BUILDING COMPLETION REPORT.

Re: Amended plan for building on plot No.182

AMENDED PLAN
ON PLOT NO 182 SHEET NO E 7 RUNCHORE BR
SCALE 8"=1"

PLAN OF PROPOSED BUILDING
ON PLOT NO 182 SHEET NO E7

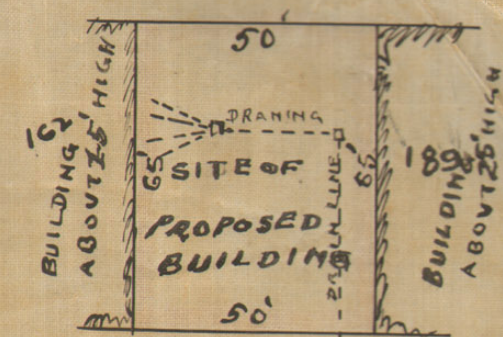
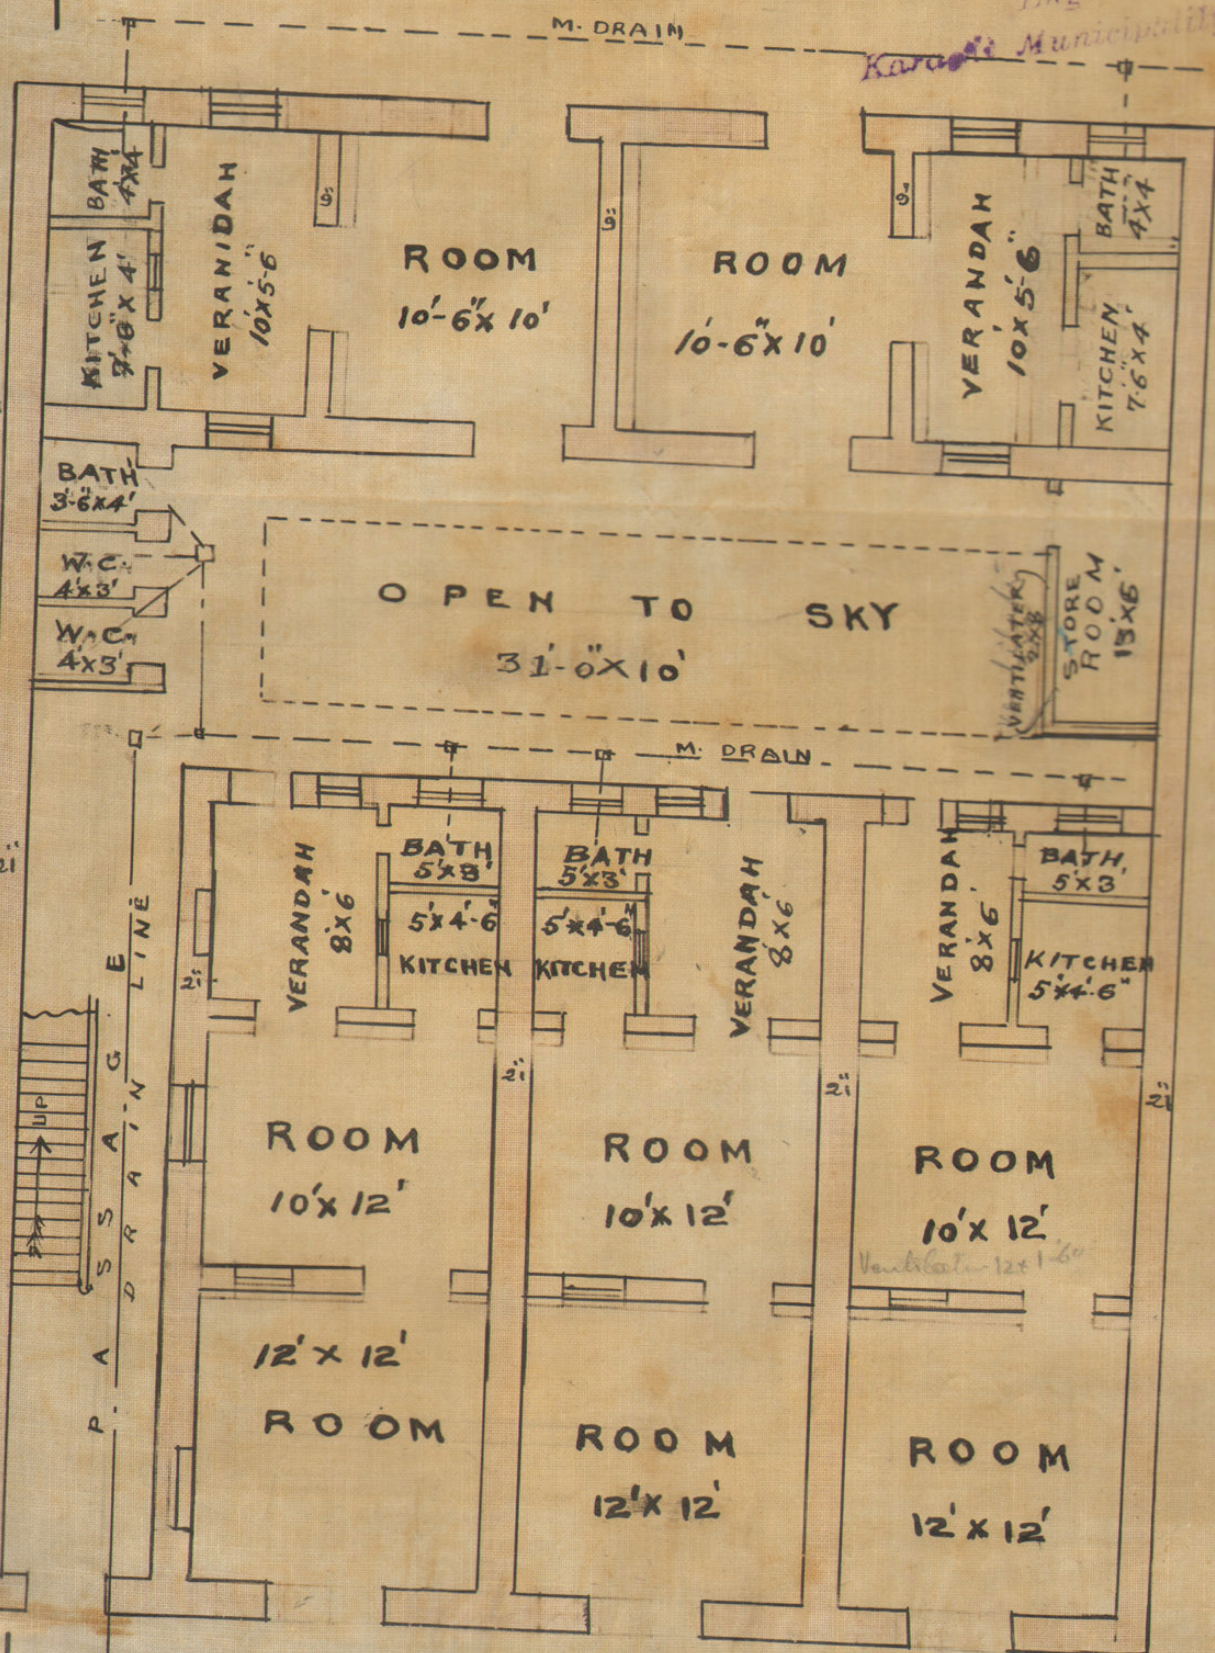
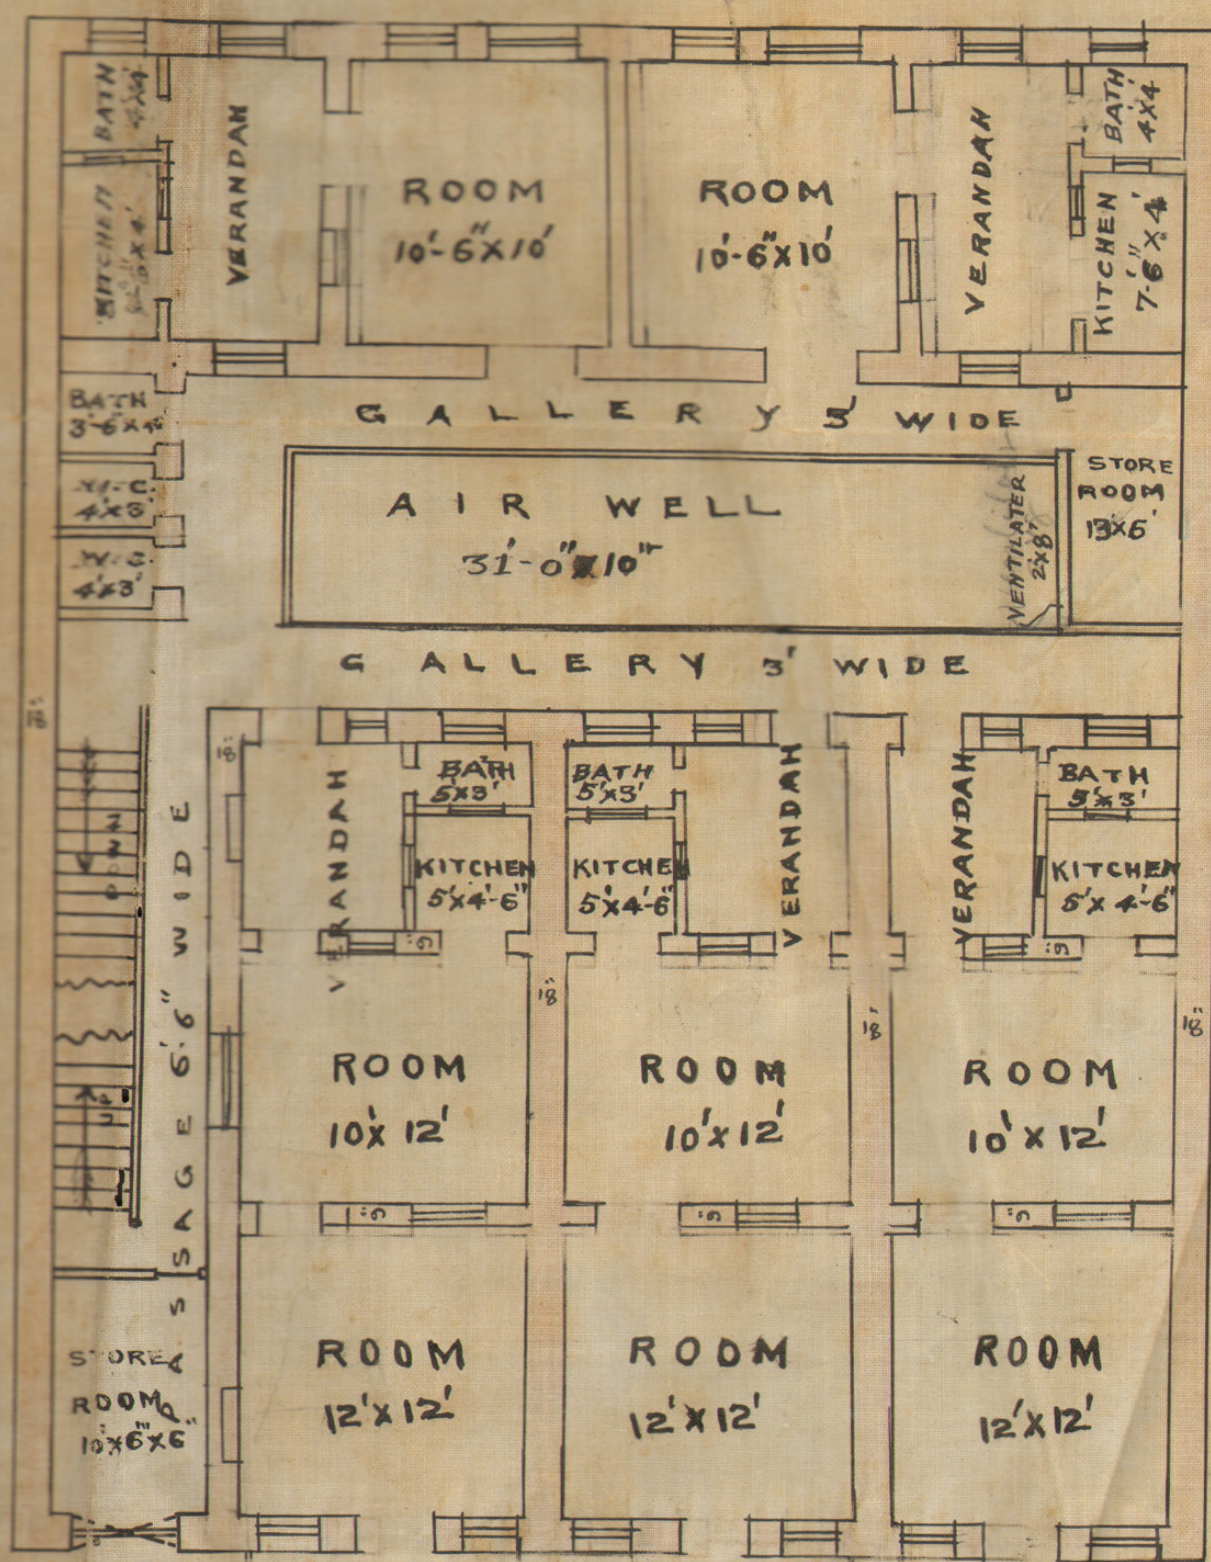
Exp alt of
Hume to 88.0

Submitted with report.
there is no objection to
approve the plan
16/5/21

Submitted to the Engineer for
order. There appears no
objection to approve the
amended plan of the bldg.
as already constructed.

Mr. Shivji Ganesh is informed, that there is no objection to the plan.

One copy of plan is returned herewith duly approved.

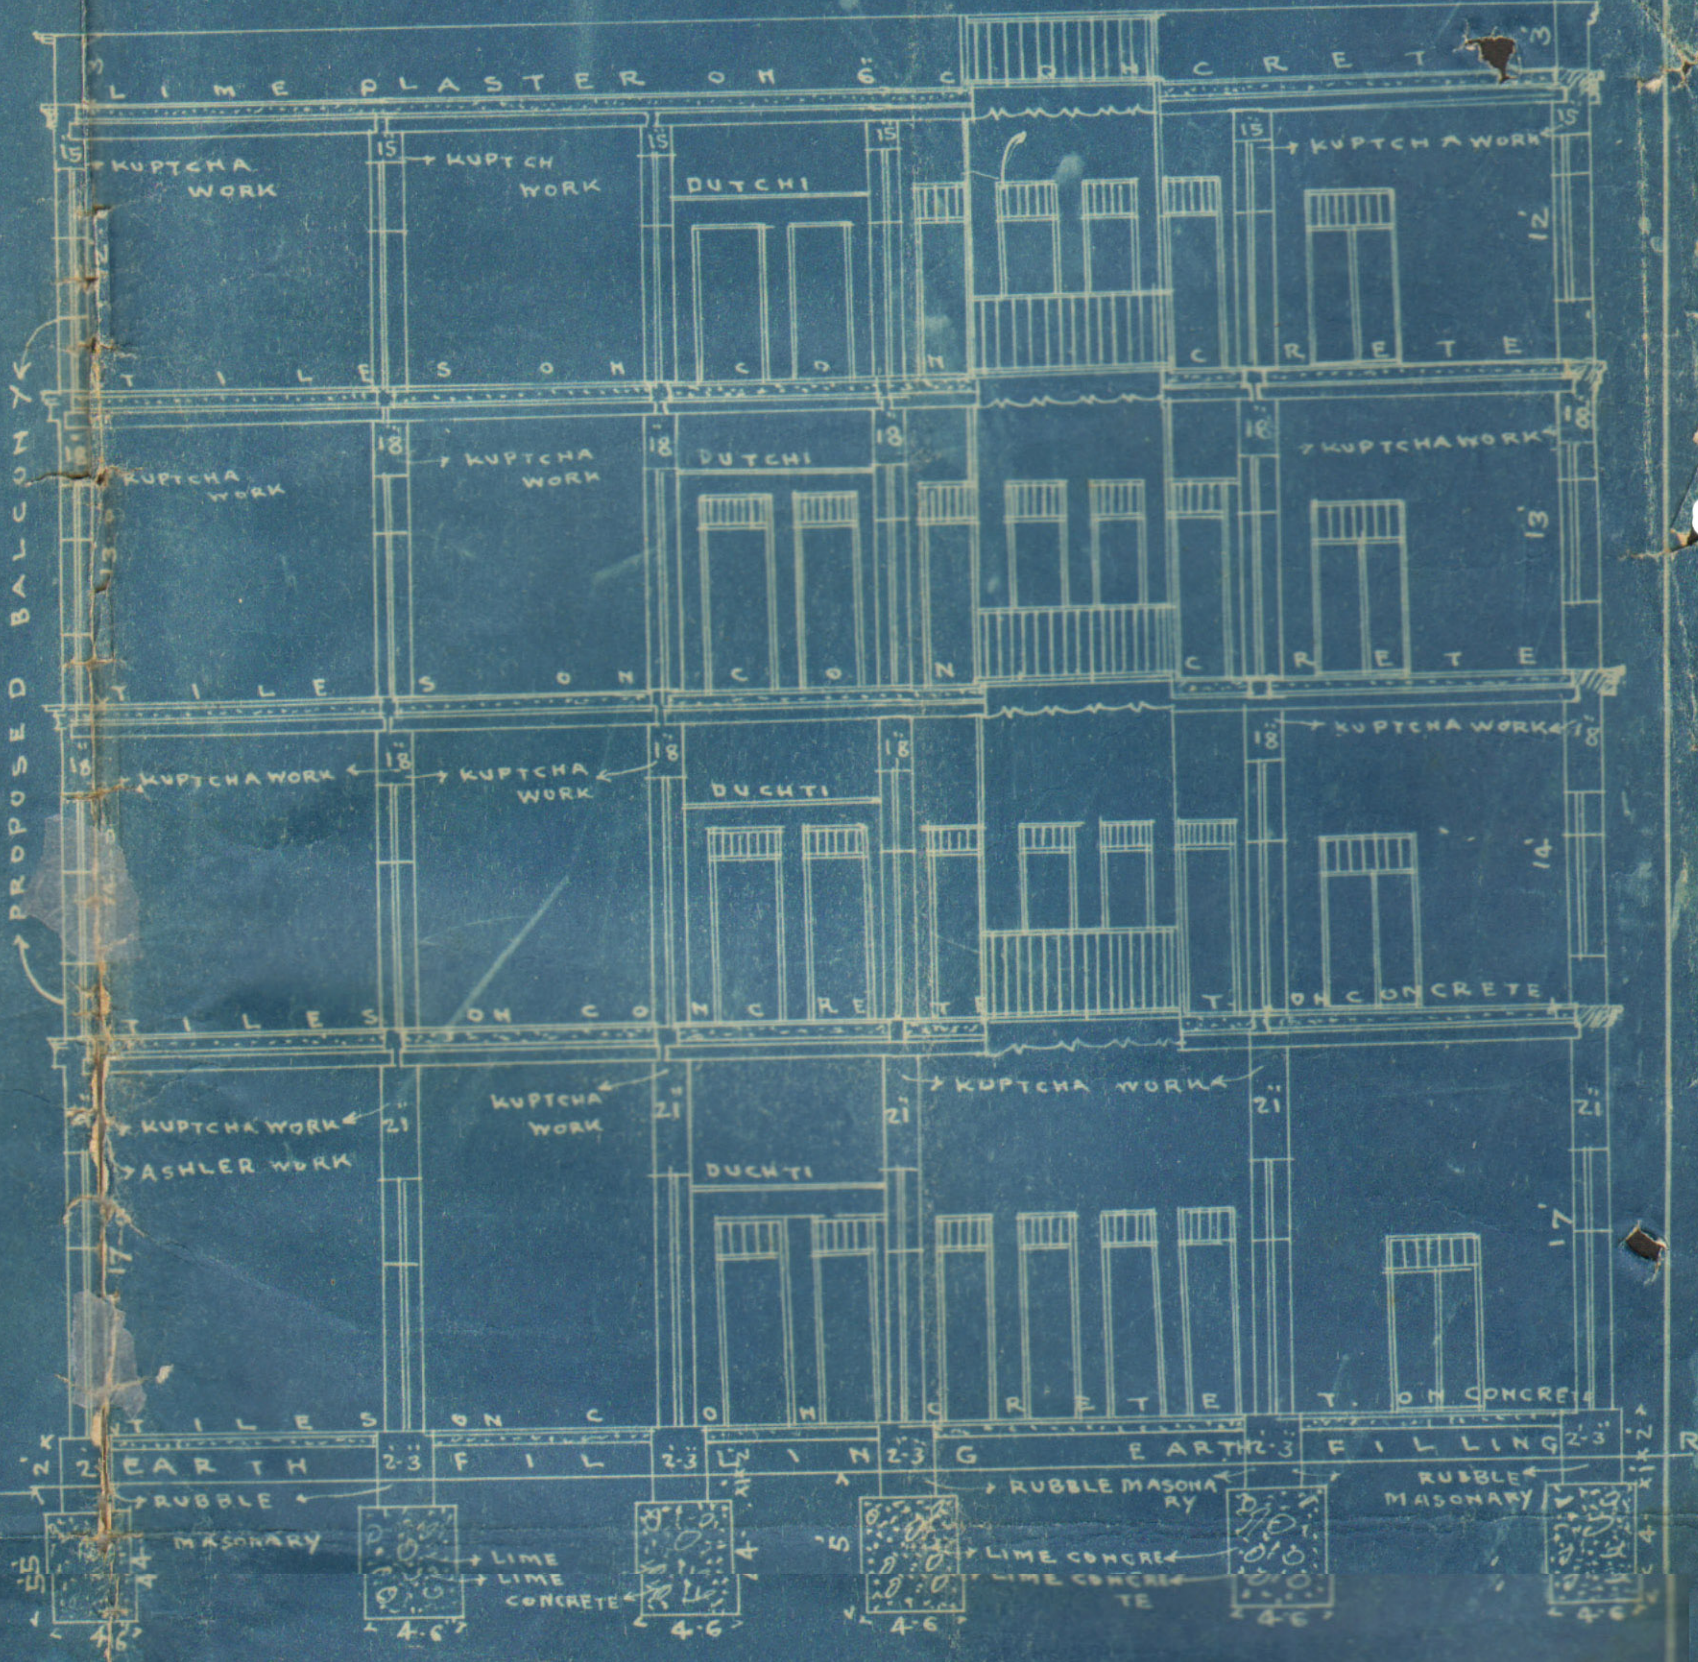
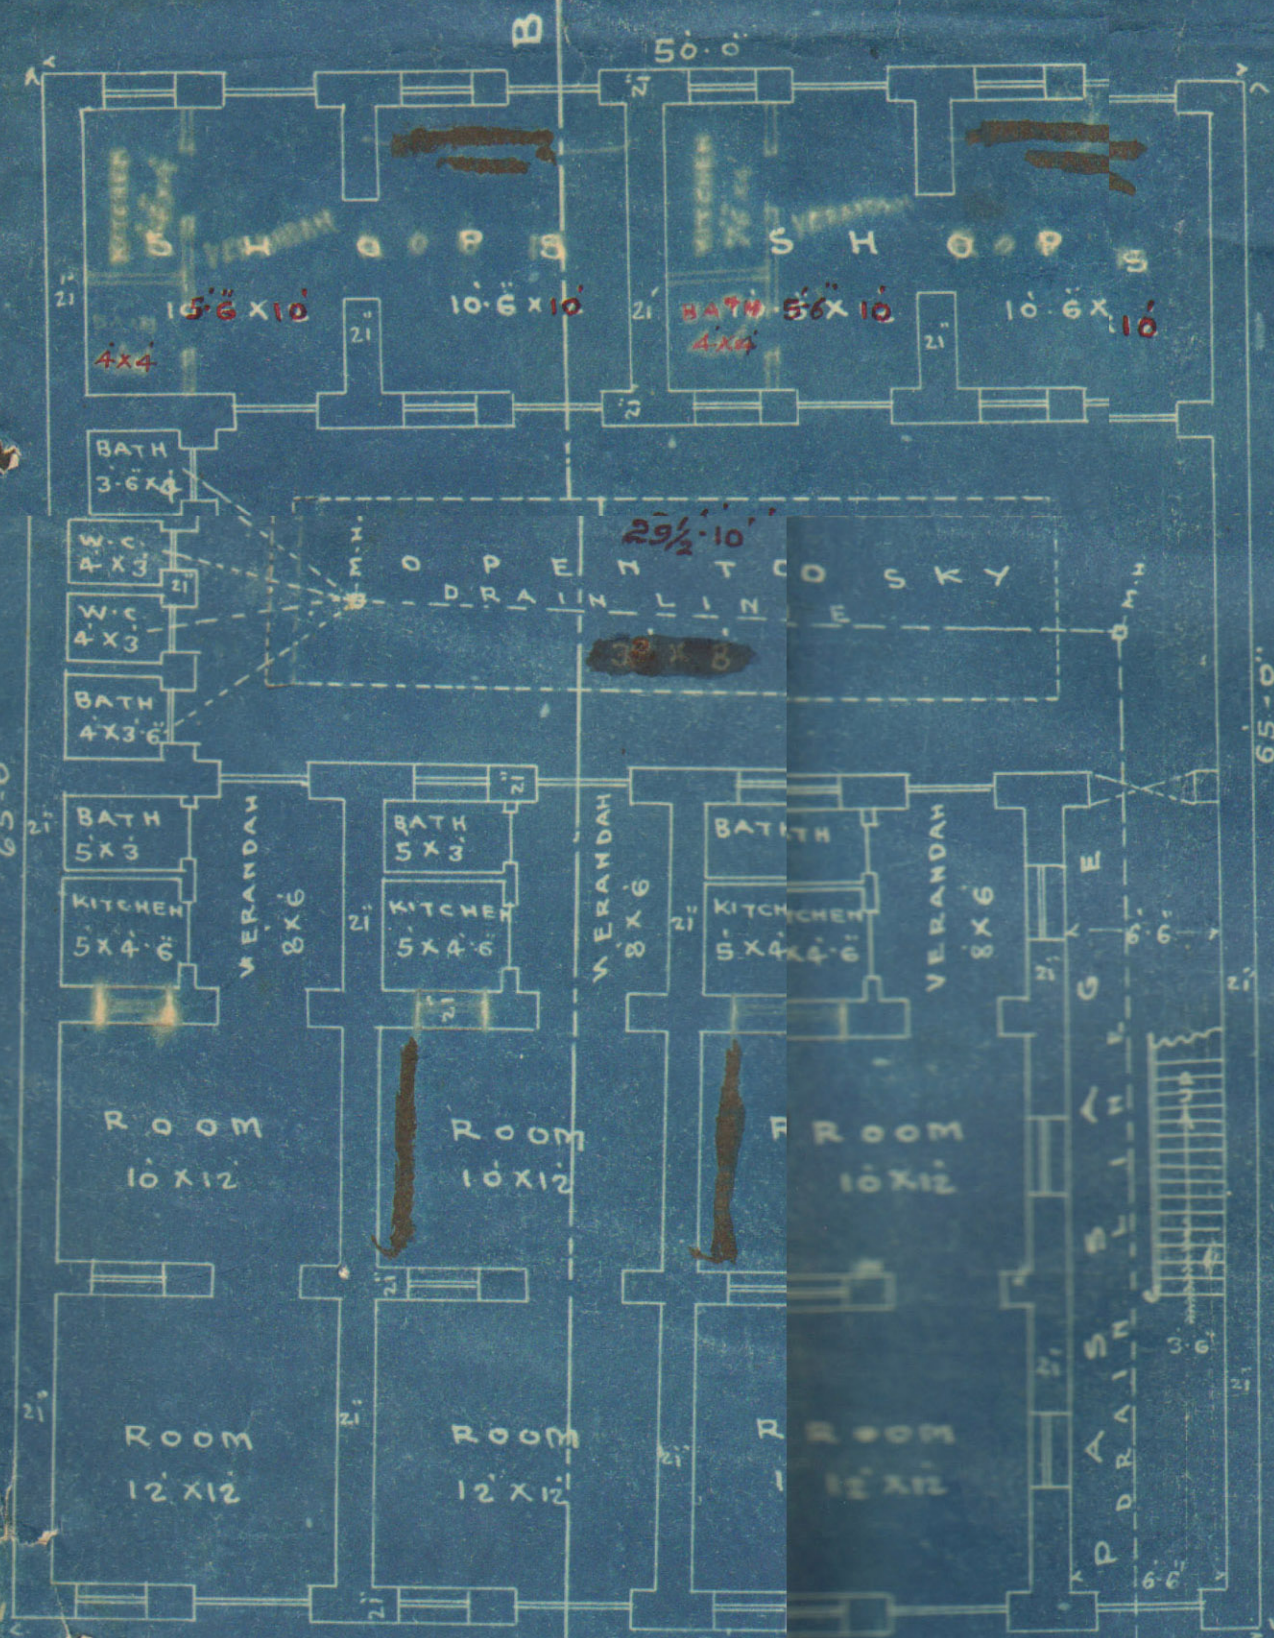
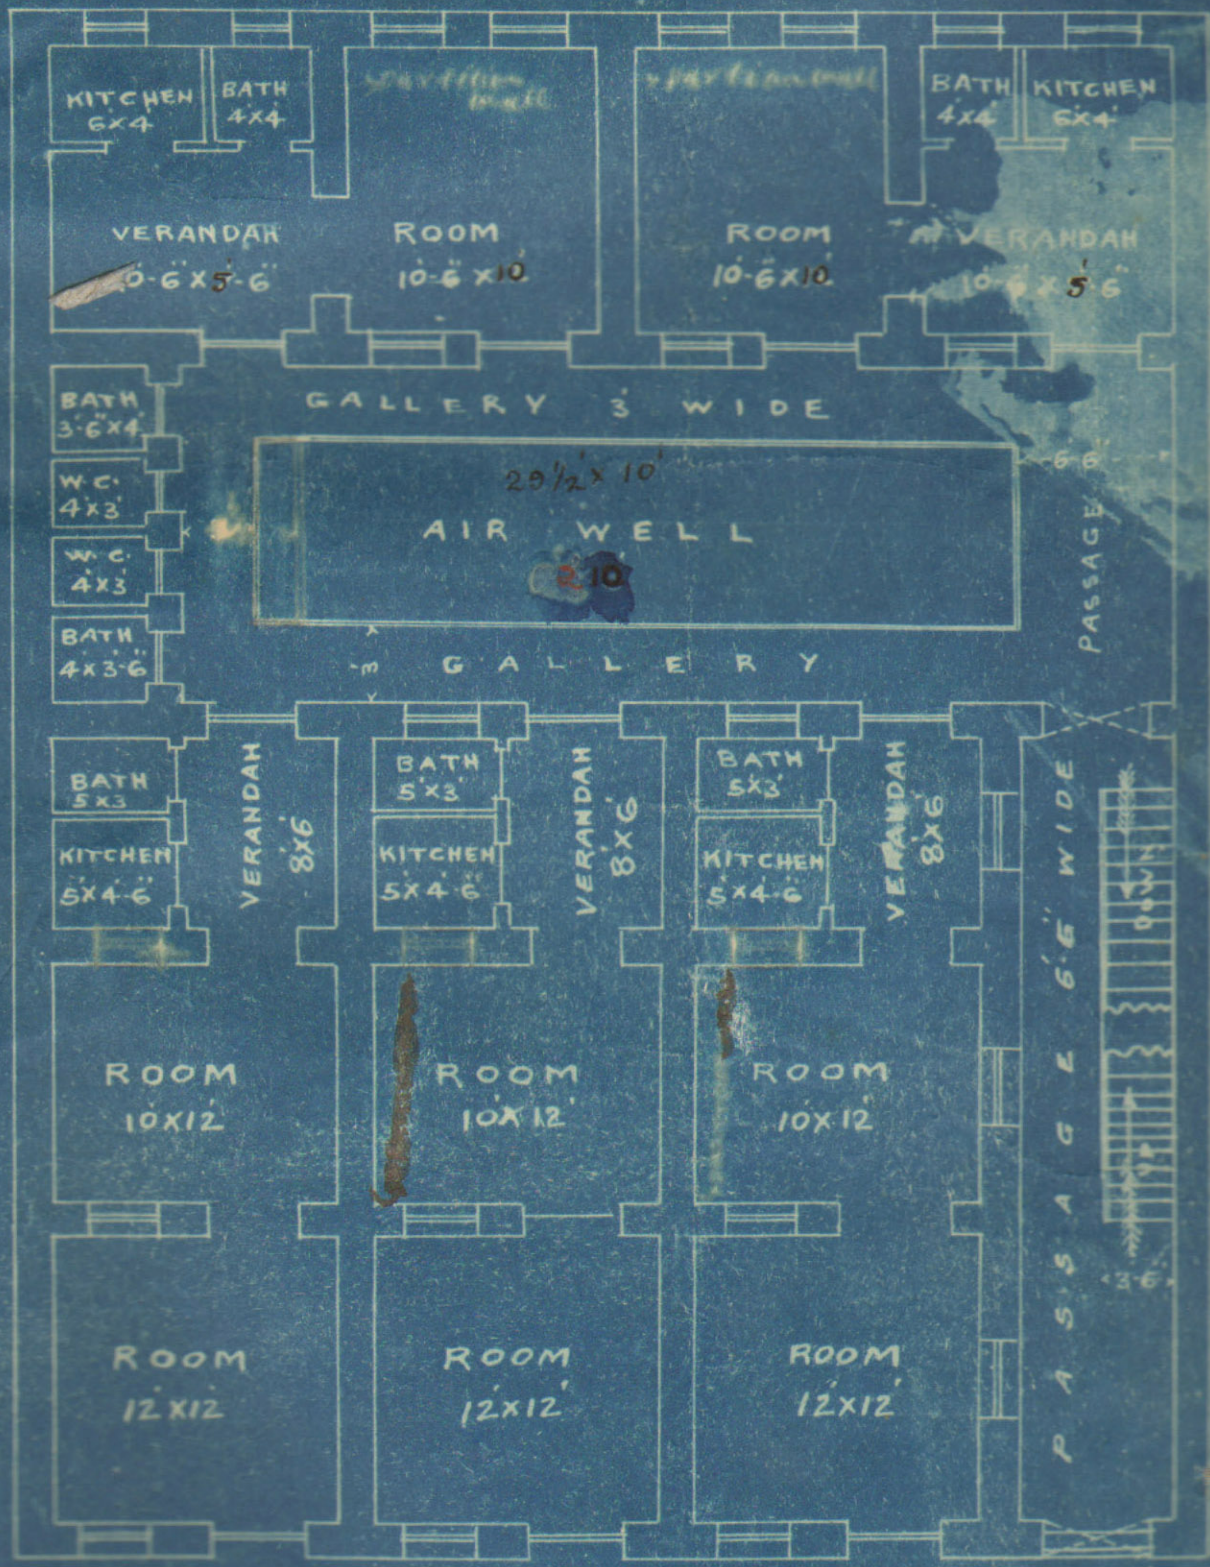
In continuation of this office letter No: L. S. 128, dated 5th March 1921, Mr. Shivji Ganesh owner of plot No. 182, E-7 Runchore Quarter is informed, it is observed, he is - pushing on with the building work contrary to the approved plan, inspite of the notices given to him to stop the work.

Block ^{of} sanitary conveniences consisting of 2 water closets & 2 baths must be constructed as approved and the insanitary rooms erected without permission in the passage to the South East of the plot must be removed at once on all the floors, failing which, steps will be taken under the Act.

2/- The rooms on the ground floor are not provided with windows according to the approved plan, which has made them dark & without ventilation.

In continuation of this office letter NO. L.S. 8001 dated 19th January 1921, Mr. Shivji Ganesh owner of - plot No. 182, E-7 Runchore quarter is informed, it is observed, in addition to the change of passage on the ground - floor from South to North, he is putting up lofts over the rooms to the East contrary to the approved plan.

he is deviating from the approved plan in as much as passage shown to the South has been kept to the North. The east to west partition wall of rooms have been made of woodwork instead of stone masonry. 2/ The distances between balconies is kept less than 3 ft, which contravenes byelaws 48 (1) & 113 (3) & (4).

He is here-by requested to stop further work and to remove the lofts in rooms, contrary to the Byelaws and to submit an amended plan within 7 days from receipt hereof, failing which, steps will be taken under the Act.

Instructions are therefore given to him to at once stop the work and make the building in conformity to the approved plan, or steps will be taken under the Act.
